Service Bulletin No. RT20060915
Subject: Nozzle Studs/Retaining Nuts
Models: MT-76D2/MT-86D2
Product Group: Rammers
Date: September 15, 2006

SERVICE BULLETIN

Figure 1. Retainer Nozzle

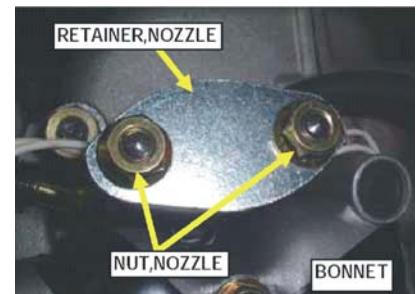
3. Place the retainer nozzle over the two studs.
4. Thread (hand tighten) the two retaining nuts (P/N 26366060002) over the studs to keep the retainer nozzle in place (Figure 1). Remember to only hand-tighten the retaining nuts.

Figure 3. Cylinder Head

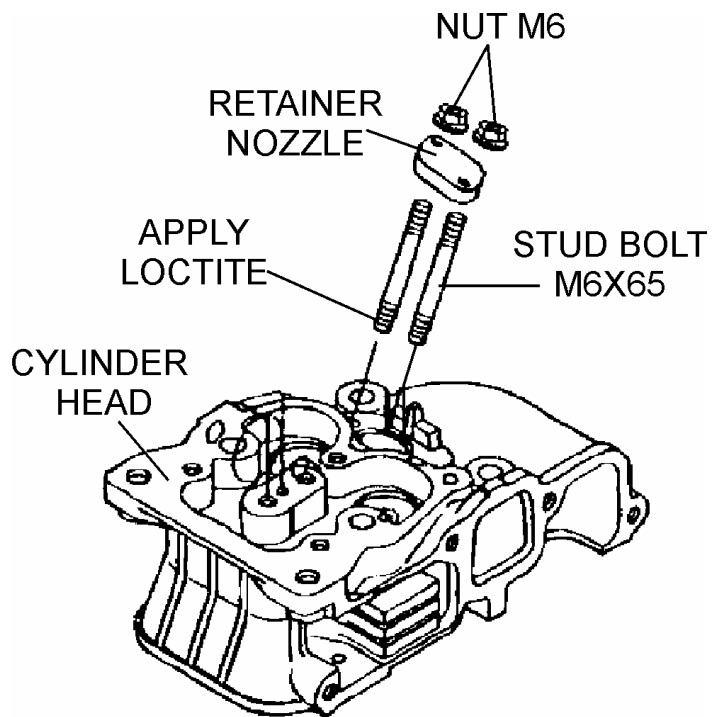
1. Using vise grips, remove the broken nozzle stud bolts from the cylinder head.
2. Apply loctite to the cylinder end (Figure 3) of the nozzle stud bolts (P/N 11471811910) and insert them back into the cylinder head. Tighten securely.
